UNITED STATES PATENT AND TRADEMARK OFFICE

10/533,938

Office Action Summary	Application No. 10/533,938	Applicant(s) HOOGLAND, HENDRICUS ANTONIUS	
	Examiner SEYED M. MALEKZADEH	Art Unit 1791

DETAILED ACTION

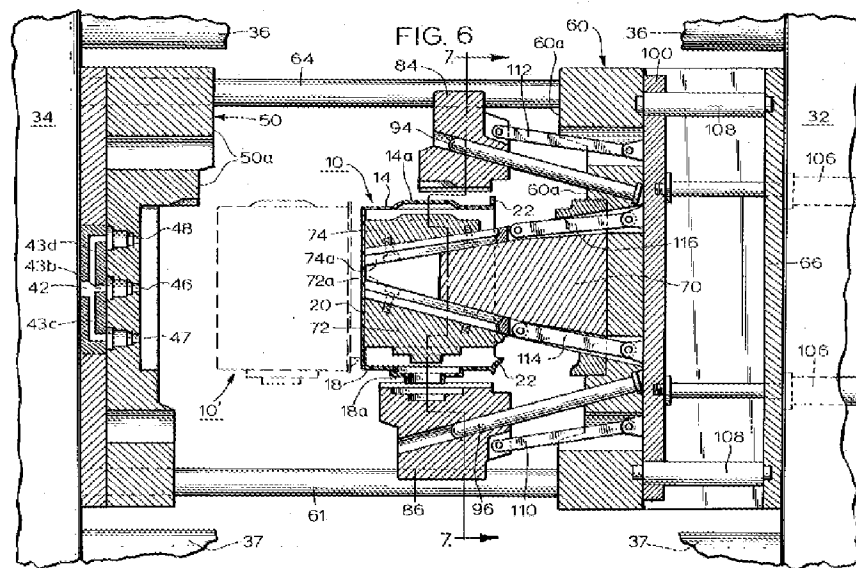
a mold defining surface corresponding to the exterior dimensions of typical molded plastic article made, and a second mold section (60) as a second mold part which is fixedly secured to the movable platen (32) and is disposed in opposed facing relation to the first mold section (50). (See lines 31-36, column 3 and lines 61-67, column 3 and figure 6)

Furthermore, the prior art teaches the mold (30) includes a sidewall mold means comprising four separable sidewall members (80, 82, 84, and 86). The sidewall members (80, 82, 84, and 86) are interposed between the first and second mold sections (50 and 60) and in the closed position of the mold (30) correspond with the first mold section (50) to define the exterior sidewall contour of the molded article (10). (See lines 36-51, column 4) Furthermore, the sidewall members are each supported and guided by respective pairs of guide rods (90, 92, 94, and 96) of a guide means structure in which each pair

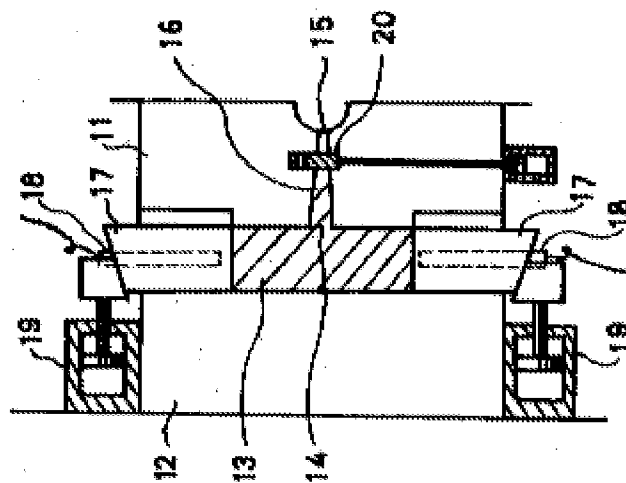
Moreover, Lovejoy et al ('740) teach the four sidewall members (80, 82, 84 and 86) are each formed as rectangular blocks and inter-fit in an overlapping relation. The sidewall elements in their closed position, collectively define the exterior sidewalls in the face contour of the mold cavity. (See lines 32-39, column 6 and figure 5) Also as shown, in an open position of the apparatus, the wall parts, together, provide a space volume which is greater than the volume of the wall parts in the closed position. (See figure 6 and lines 38-45, column 7)

Therefore, **as to claim 1**, Lovejoy et al ('740) disclose a mold apparatus comprising two mold parts (50 and 60), movable relative to each other in a first direction of movement; also the mold apparatus include a mold cavity in which the mold cavity being provided on both mold parts (50 and 60), and also four slide-able rigid wall parts movable in a second direction movement which are moveable between a first retracted position and a second expanded position while the mold cavity with the wall parts in the second position are in a product forming position and wall parts in the first position have a volume greater than with the wall parts in the second position while the first and the second direction of movement mutually include an angle.

However, Lovejoy et al ('740) **fail to teach** the slid-able wall part also is movable within the mold cavity in a closed mold position, as claimed in **claim 1.**

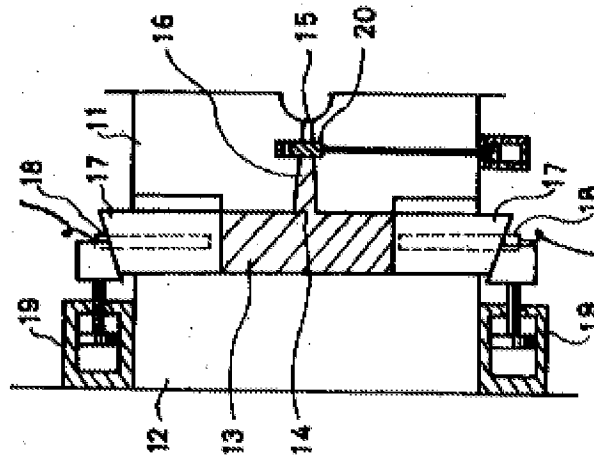
Furthermore, the central core part (21), the second core parts (50), and the movable wall parts (42, 44, 46, and 48) define a mold cavity, and the central core part and the movable wall part are disposed on the opposite sides of the second core part of the mold part and the movable wall parts (42, 44, 46, and 48) in such a way that the movable parts (42, 44, 46, and 48) are located at the side directions of the second core parts (50) facing away from the central core part (21); furthermore, the movement of the wall parts (42, 44, 46, and 48) are directed toward the second core parts (50) and the molten material is pushed by the wall parts against the first centered core part (21) and the second core parts (50). Furthermore, the moveable wall parts (42, 44, 46, and 48) of the mold are arranged for forming longitudinal walls of the cavity, and in an open position of the apparatus, the wall parts, together, provide a space volume which is greater than the volume of the wall parts in the closed position. (See lines 43-75, column 3 and lines 37-75, column 4; figures 2-3).

Furthermore, McDonald ('292) discloses a plurality of hydraulic cylinder means (56) as drive means which each include piston rods (66) connected to the wall parts (42, 44, 46, and 48) to extend or retract the wall parts (42, 44, 46, and 48) from the mold cavity. (See lines 51-57, column 4) Therefore,

McDonald ('292) teaches a plurality of separate and independently moveable wall parts to correspond with other mold members to form a mold cavity.

However, McDonald ('292) **fails to teach** the slid-able wall part also is movable within the mold cavity in a closed mold position, as claimed in **claim 1** to provide a force against the molten plastic inside of the mold cavity in an extended position of the movable wall parts, as claimed in **claim 7**.
